ADDENDUM 001

Date: **May 27, 2026**
To: **Construction Documents, Dated 05.18.26**
Project: **#3038 ASU Career Readiness, Education, & Skills Training Center**

LIFE SAFETY
1/8" = 1'-0"

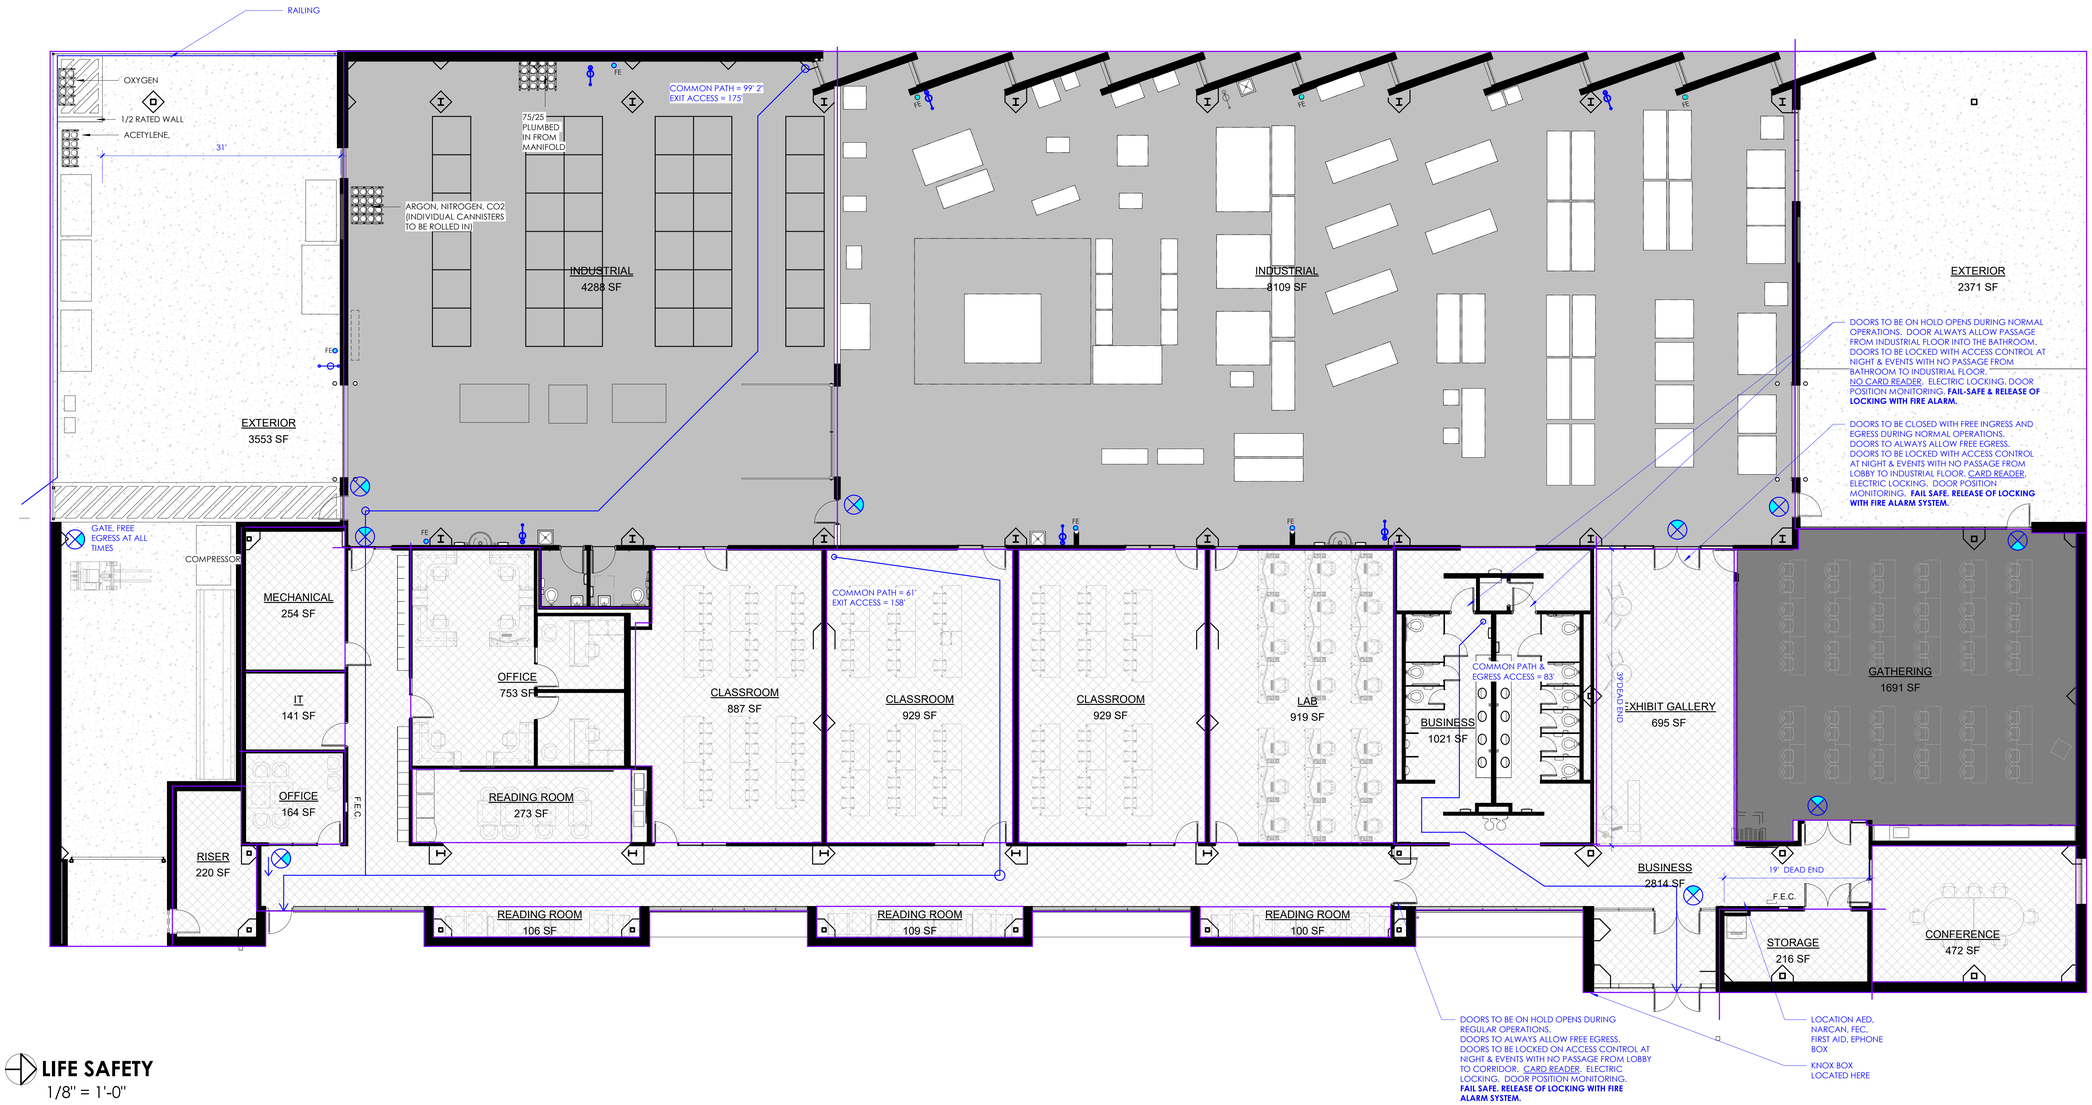
c. **REPLACE** Sheet G0.20 LIFE SAFETY with the attached for the following revisions:
   1. **REVISE** Construction Type: IIIB
   2. **REVISE** Allowable Area: 78,980 SF and Allowable Area Chart
   3. **REVISE** Allowable Height: 75'
   4. **REVISE** Fire-Resistance Rating Requirements for Building Elements: Exterior Bearing Walls: 2 hrs.

SITE PLAN C1.01

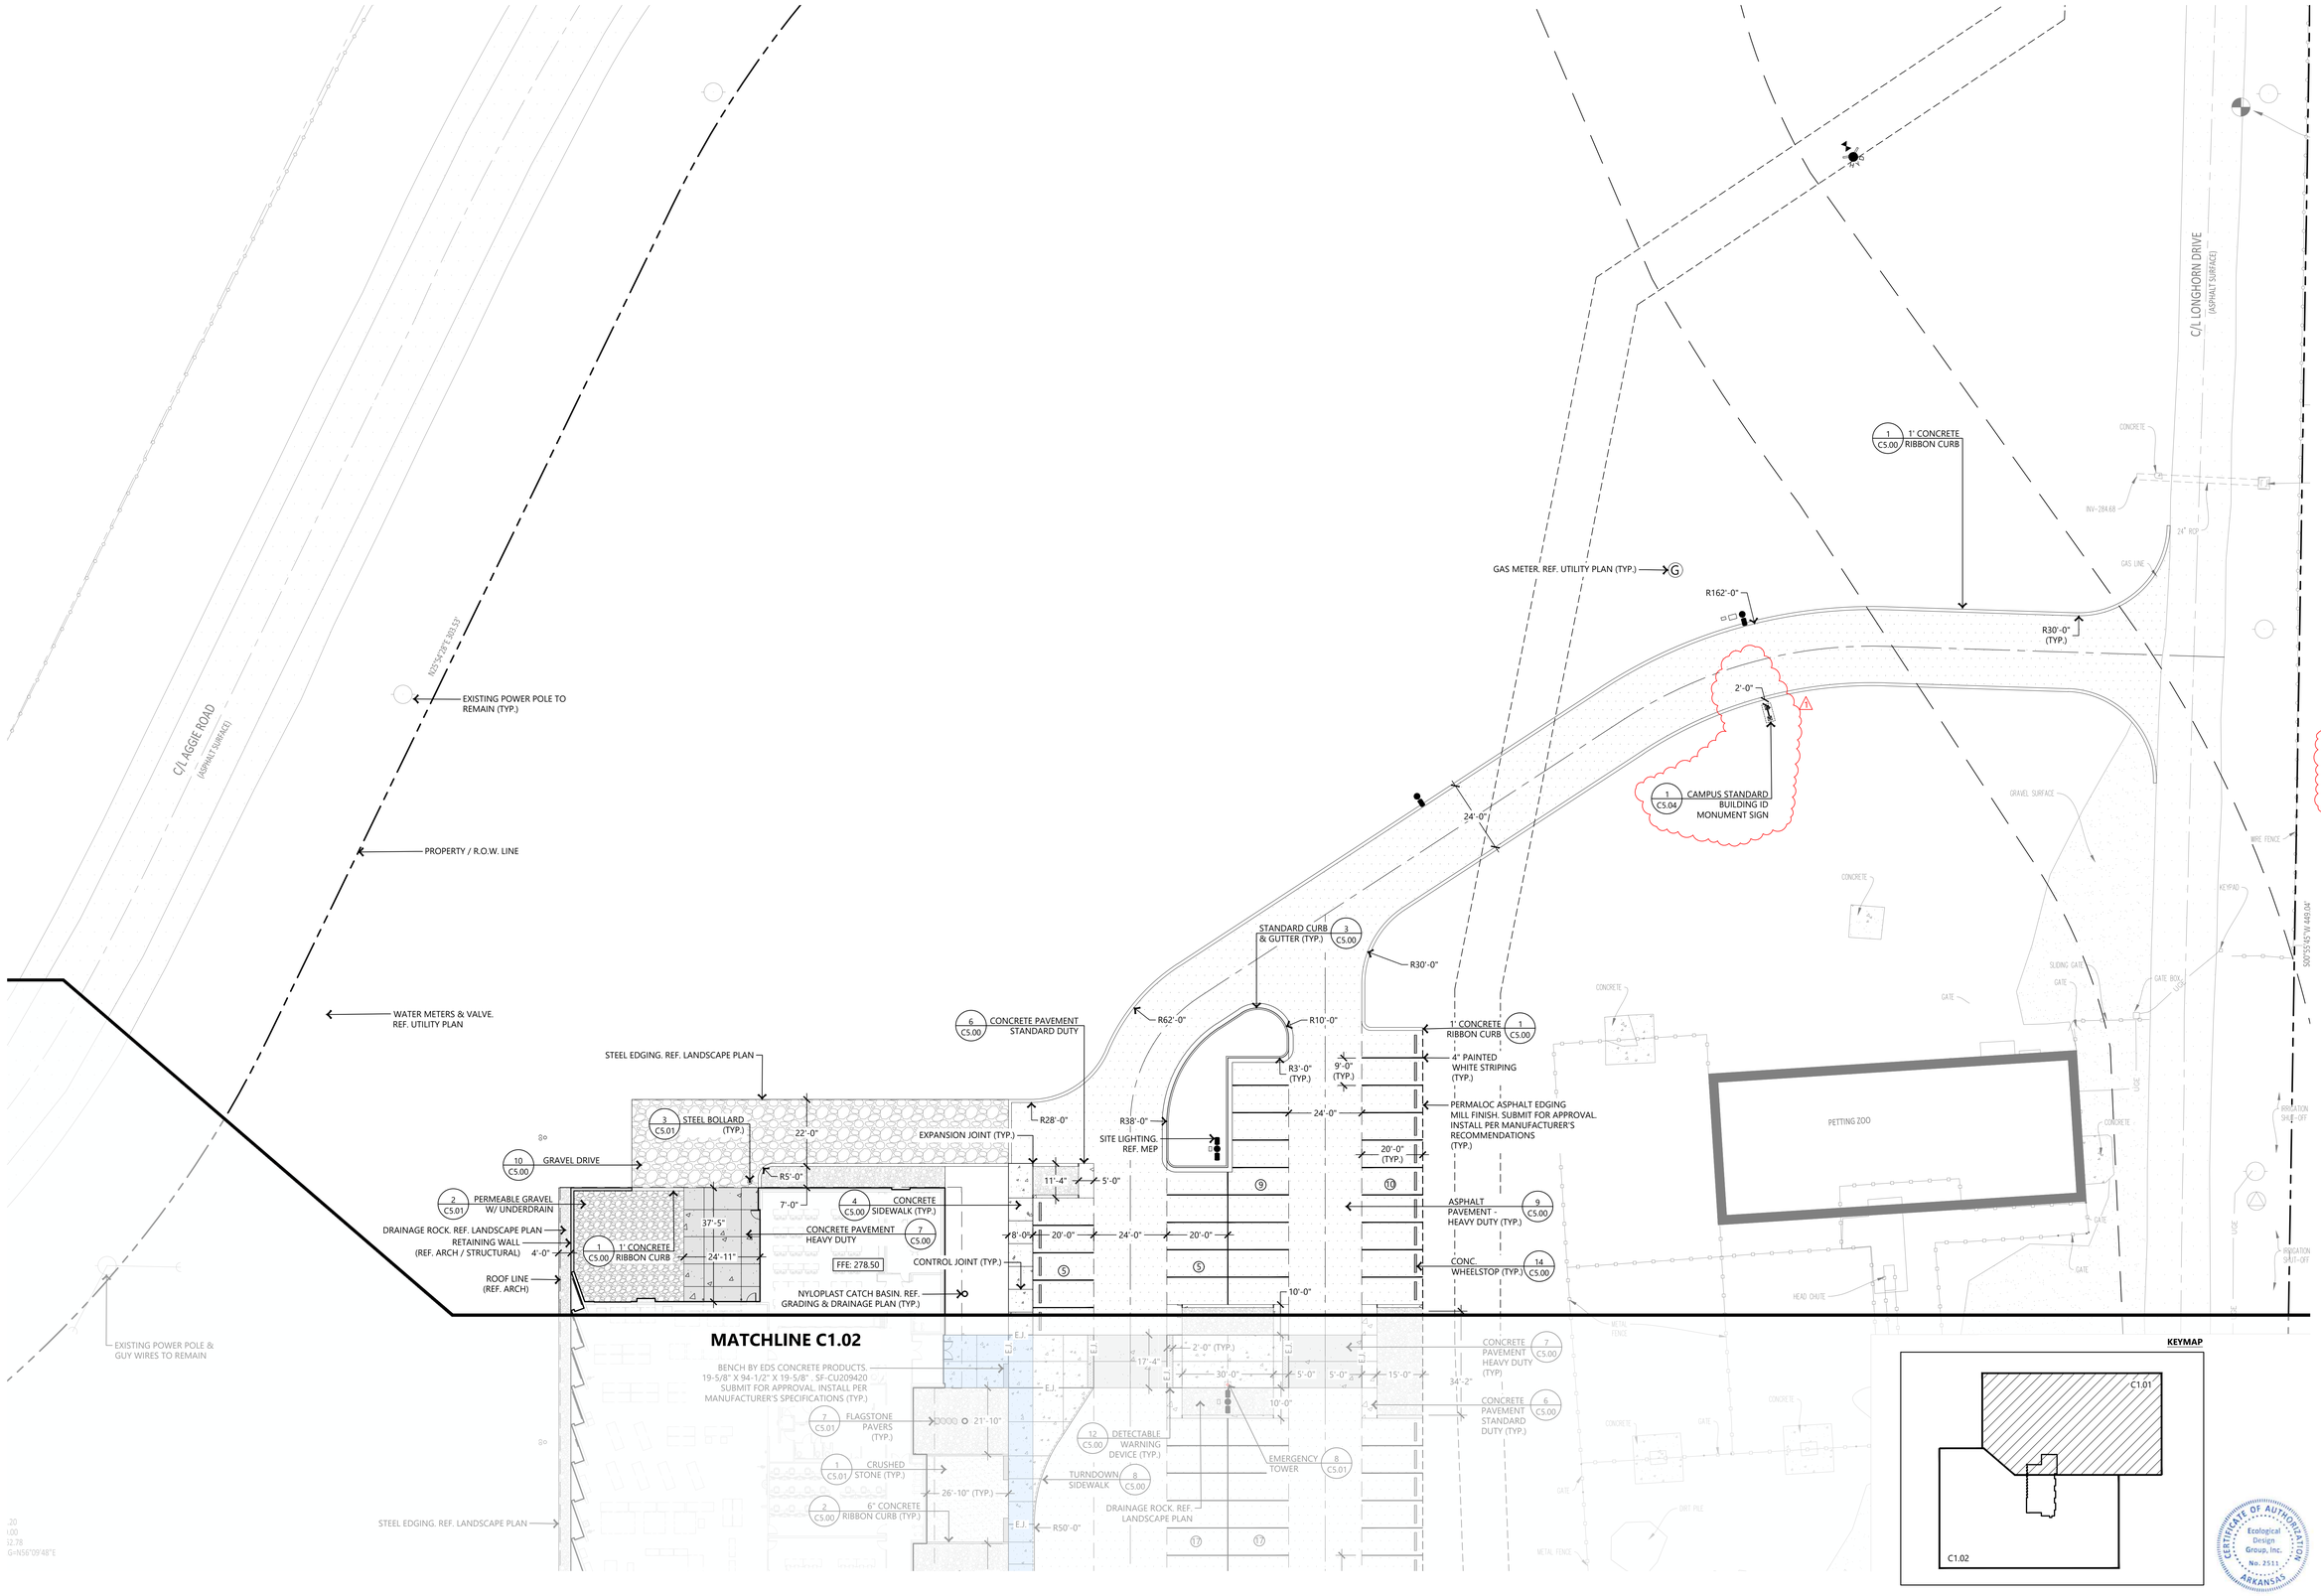
Sheets	Sheet Name/Specification Section	Brief Description of Changes
C1.01	Site Plan	1. Added Campus Standard Building ID Monument Sign linework and associated callout and dimensions. 2. Added 811 logo to titleblock.
C1.02	Site Plan	1. Changed curb at loading area from flush concrete to standard curb and gutter. 2. Added 811 logo to titleblock.
C2.00	Overall Utility Plan	1. Water main now is proposed to connect on south side of Aggie Road at the Longhorn Drive intersection. A proposed public easement is now shown. All water lines have been revised accordingly. The point of entry to the building remains the same. 2. Added 811 logo to titleblock.
C2.01	Utility Plan	1. Water main now is proposed to connect on south side of Aggie Road at the Longhorn Drive intersection. A proposed public easement is now shown. All water lines have been revised accordingly. 2. Steel encasement will be required under the future ARDOT ROW but boring will **not** be required. 3. Proposed Water Main Shall be C-900 PVC (DR18). 4. Water line markers are indicated at all bends and beginning and ends of main. 5. A fire hydrant has been added on the north side of the future ARDOT ROW. 6. Added 811 logo to titleblock.

UTILITY PLAN C2.02

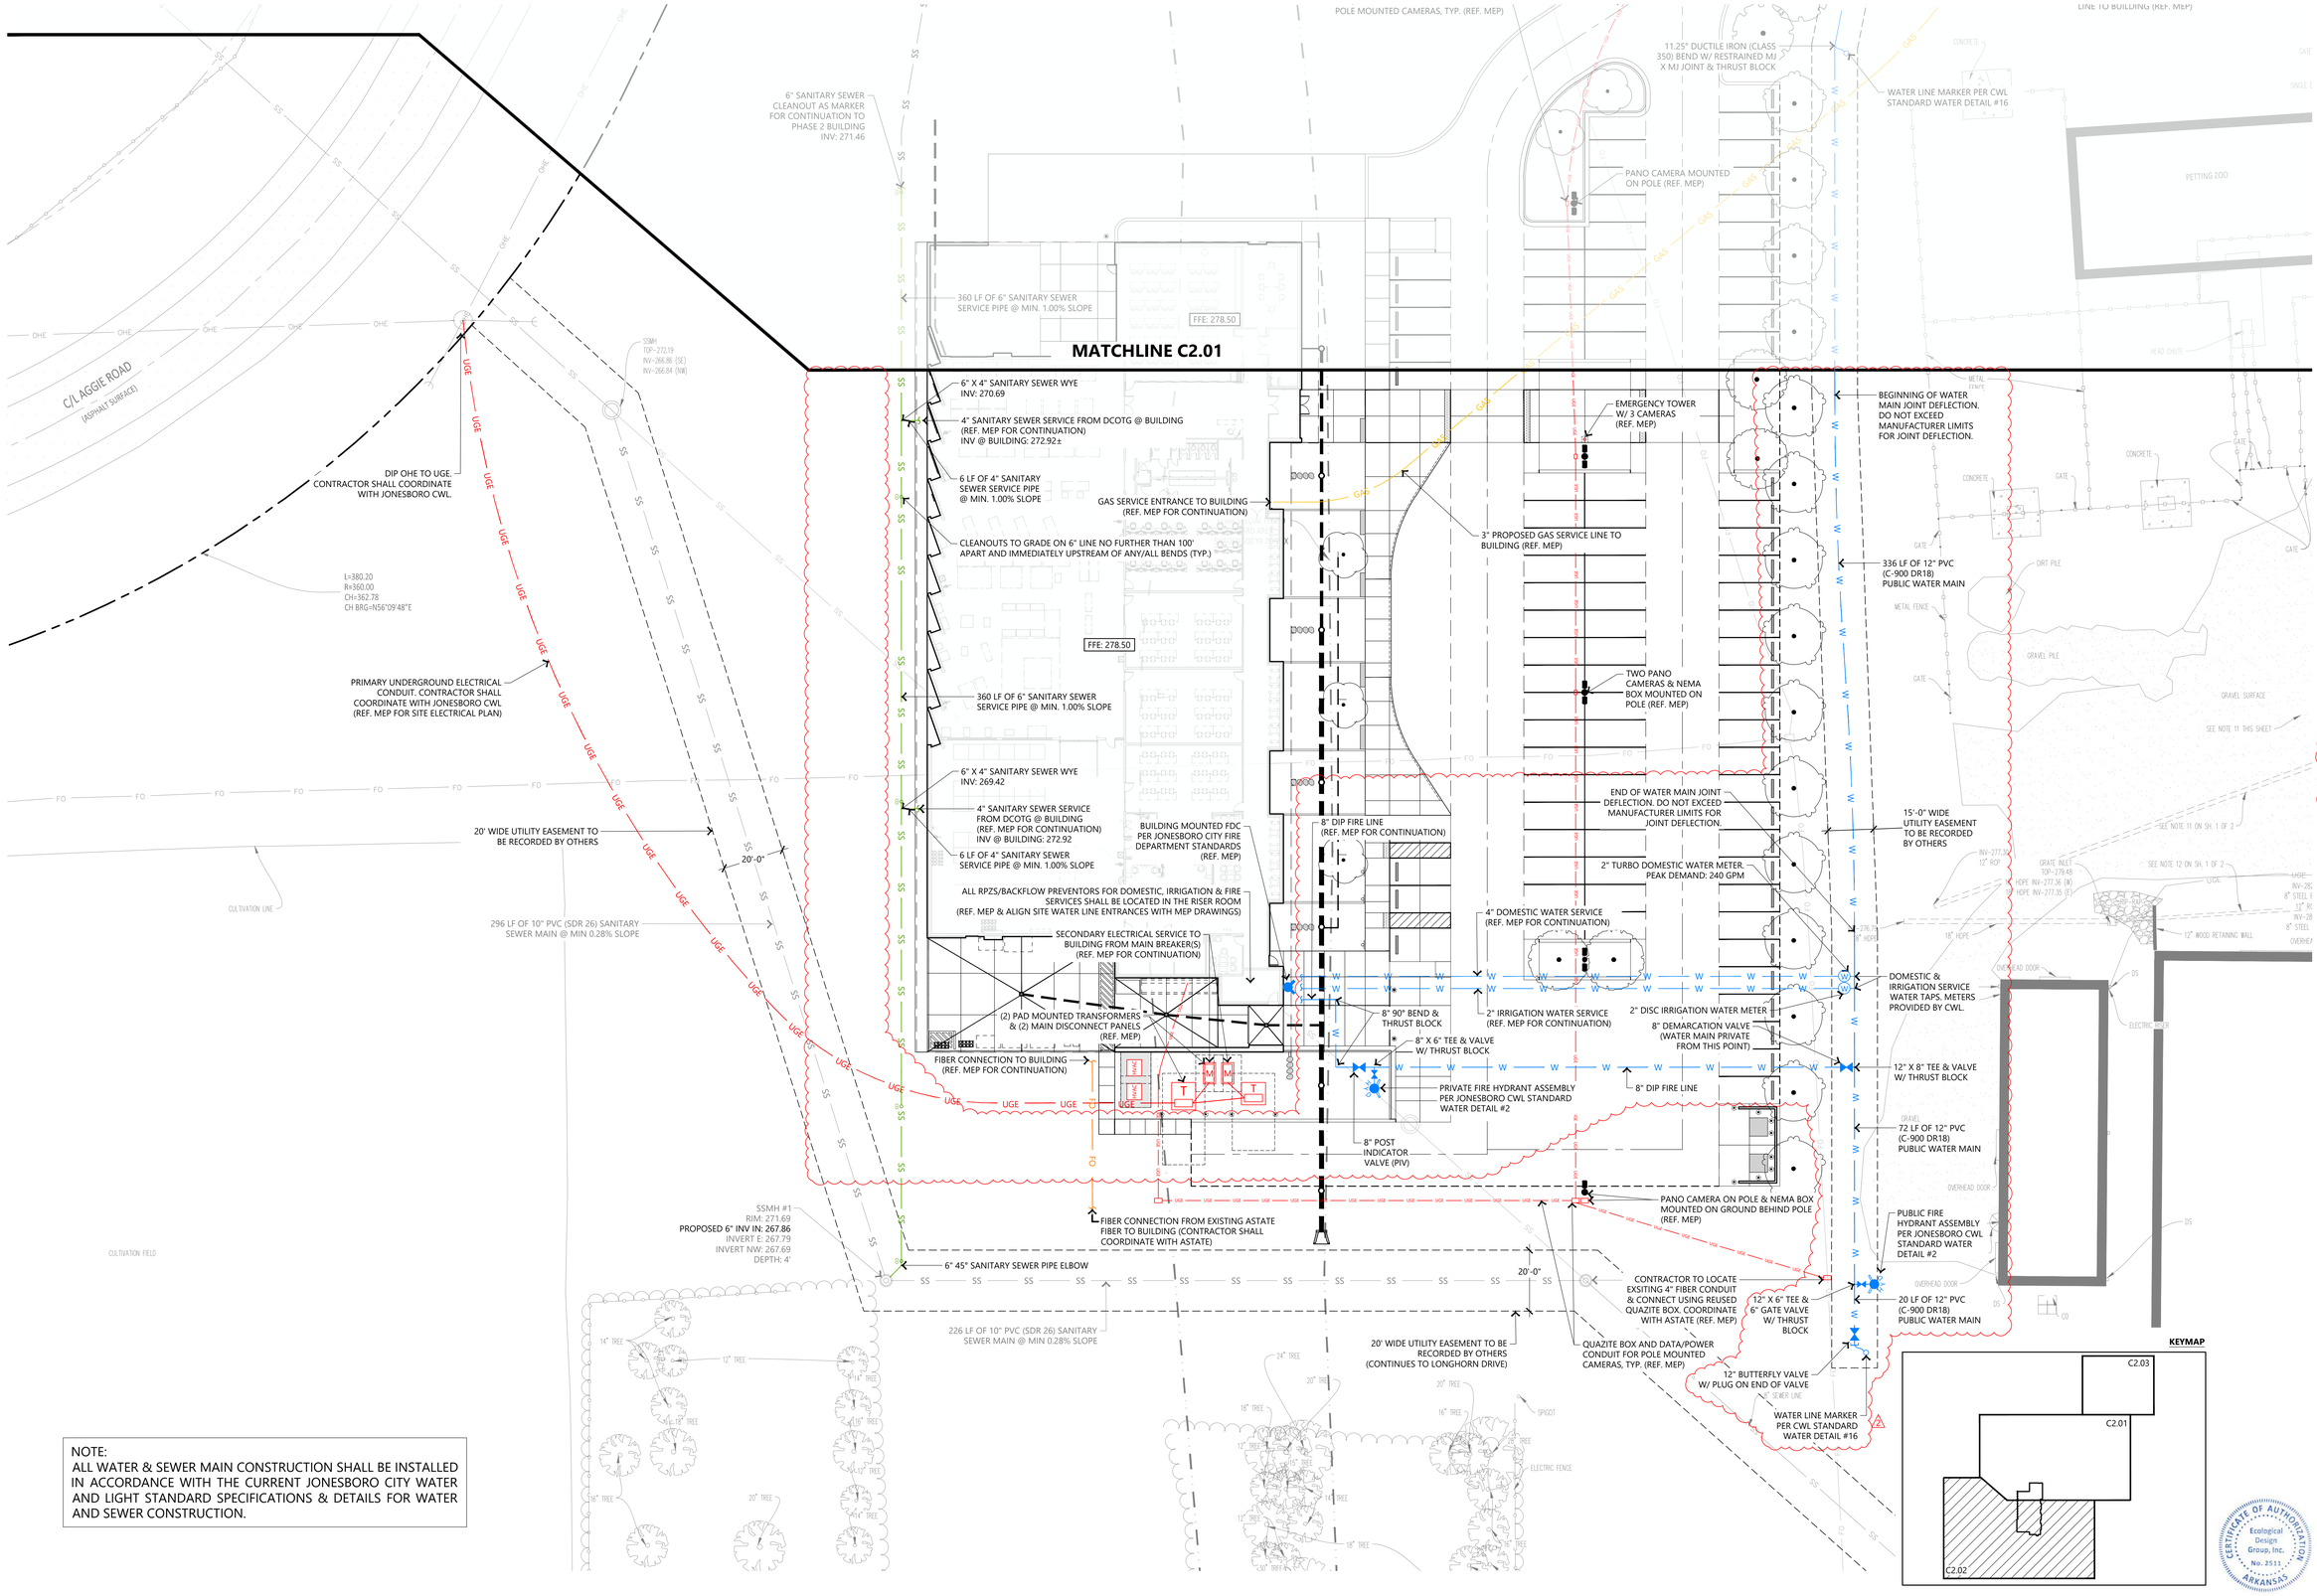
C2.02	Utility Plan	1. Water main now is proposed to connect on south side of Aggie Road at the Longhorn Drive intersection. A proposed public utility easement is now shown. All water lines have been revised accordingly. 2. Proposed Water Main Shall be C-900 PVC (DR18). 3. Water line markers are indicated at all bends and beginning and ends of main. 4. A fire hydrant has been added towards the end of the water main to be plugged for future. 5. Water meters and fire line demarcation valve are now located on the east within the proposed public utility easement. 6. Added 811 logo to titleblock.
C2.03	Utility Plan	1. Water main now is proposed to connect on south side of Aggie Road at the Longhorn Drive intersection. A proposed public utility easement is now shown. All water lines have been revised accordingly. 2. Proposed Water Main Shall be C-900 PVC (DR18). 3. Water line markers are indicated at all bends and beginning and ends of main. 4. Added 811 logo to titleblock.
